UNITED STATES PATENT AND TRADEMARK OFFICE

APPLICATION NO.	FILING DATE	FIRST NAMED INVENTOR	ATTORNEY DOCKET NO.	CONFIRMATION NO.
10/537,894	06/07/2005	Michael S. Griffith	540-565	8424
23117	7590	10/27/2006	EXAMINER	
NIXON & VANDERHYE, PC 901 NORTH GLEBE ROAD, 11TH FLOOR ARLINGTON, VA 22203			JONES, JAMES	
			ART UNIT	PAPER NUMBER
			2891

<p align="center">Office Action Summary</p>	Application No. 10/537,894	Applicant(s) GRIFFITH ET AL.	
	Examiner James C. Jones	Art Unit 2891

Figure 1

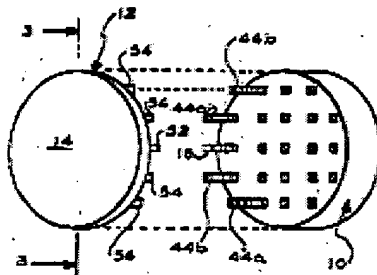
In regards to **claim 7** '848 teaches flexible tubing where the center shape of the flexible tubing is O-shaped to surround the apertures(channels) of the mirror [14] and base [10] where they terminate to face each other(see column 4 lines 20-21 and figures 1 and 2).

In regards to **claim 8** '848 teaches a plurality of posts around the periphery that terminate to form a plurality of apertures(ports) and a channel is provided in the base(mount) for each aperture. '848 also teaches channels terminating to face associated apertures(see column 4 lines 54-58 and figures 1 and 2).
